CITY OF ALBUQUERQUE

**Re: Lighthouse Relocation
4208 Balloon Park Rd. NE
30-Day Temporary Certificate of Occupancy
Transportation Development Final Inspection**
Architect's Stamp dated 10-1-20 (E17-D019F)
Certification dated 3-16-22

RE: Traffic Circulation Certification Letter for the Lighthouse Relocation Tenant Improvement

Re: **Lighthouse Relocaton**
4208 Balloon Park Road NE
Traffic Circulation Layout
Architect's Stamp 09-21-2020 (E17-D019F)

TRAFFIC CIRCULATION LAYOUT
APPROVED
10/5/20
Signed

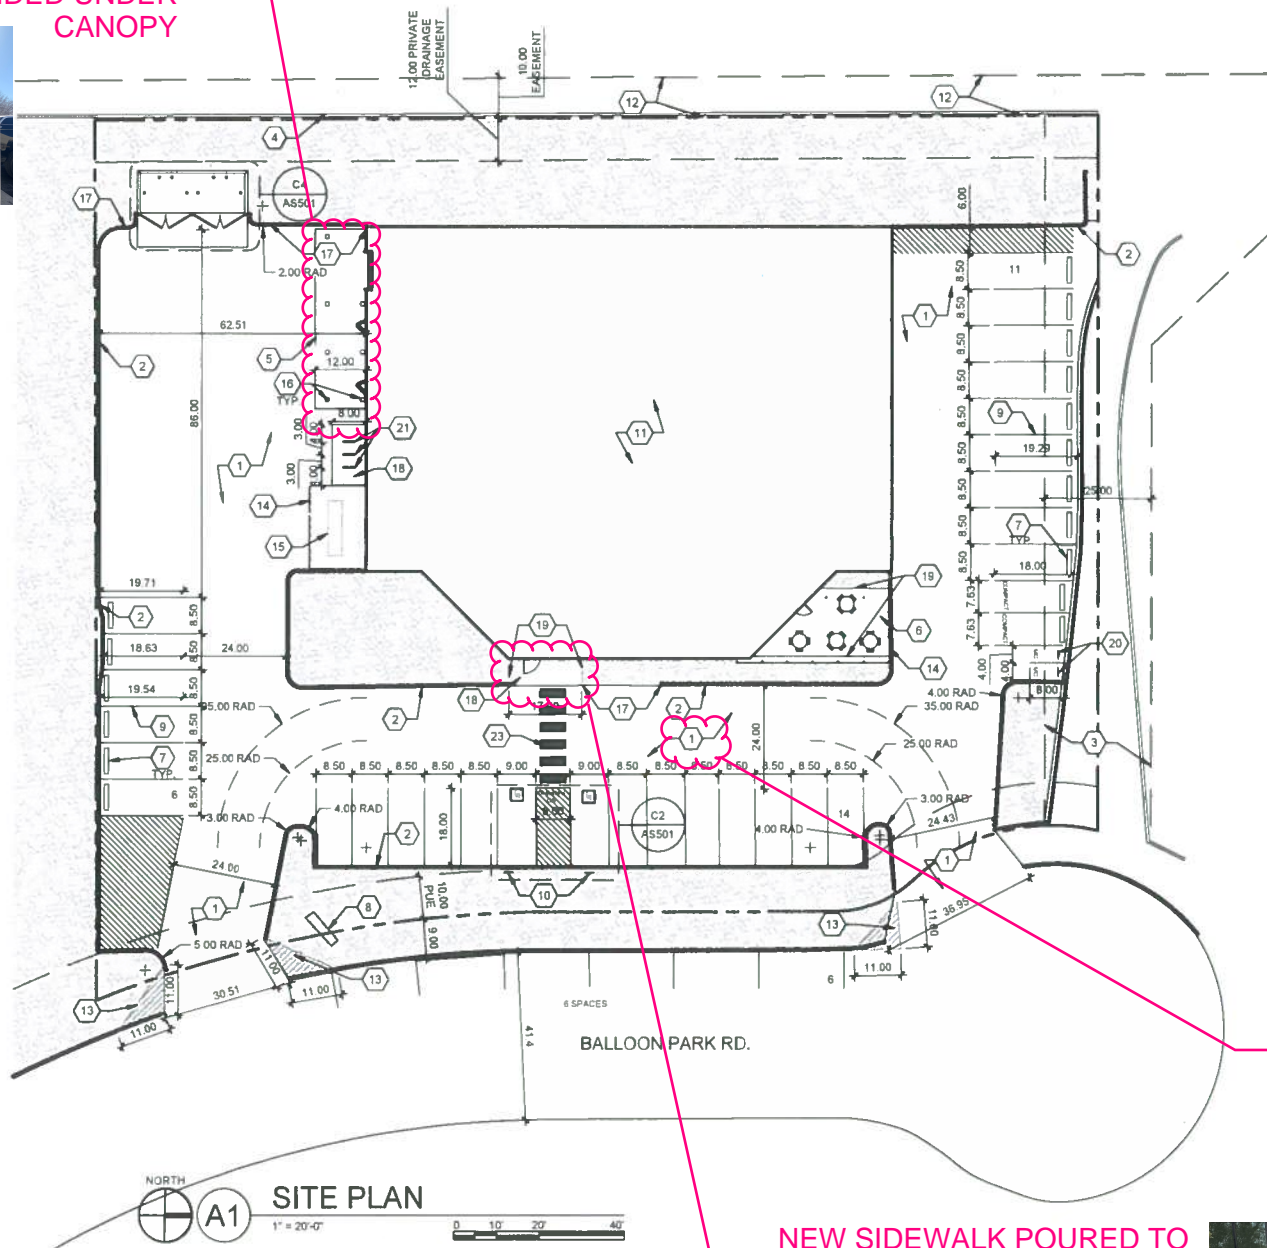
CONCRETE FROM BIKE
PARKING AND UTILITY
PAD EXTENDED UNDER
CANOPY

2" OVERLAY
DONE ON TOP OF
EXISTING, TYP

NEW SIDEWALK POURED TO
MAINTAIN ADA ACCESS WITH
EXISTING GRADES

A1 PARKING BUMPER
1/2" = 1'-0"

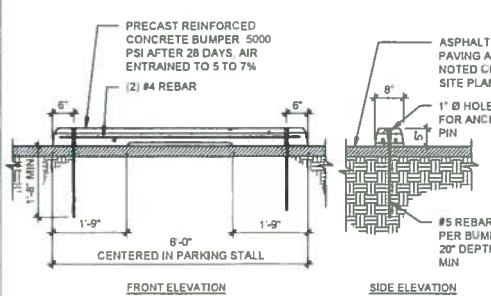
- Per DPM, a 6 ft. wide ADA accessible pedestrian pathway is required from the ADA parking stall access aisles to the building entrances. Please clearly show this pathway on the site.
- Provide Motorcycle Parking Sign, either free-standing or wall mounted per the zoning code.
- Parking Bumpers (per approved site plan) are missing on the site. Please red mark the approved site plan (TCL) and show that you have removed the Parking Bumpers.
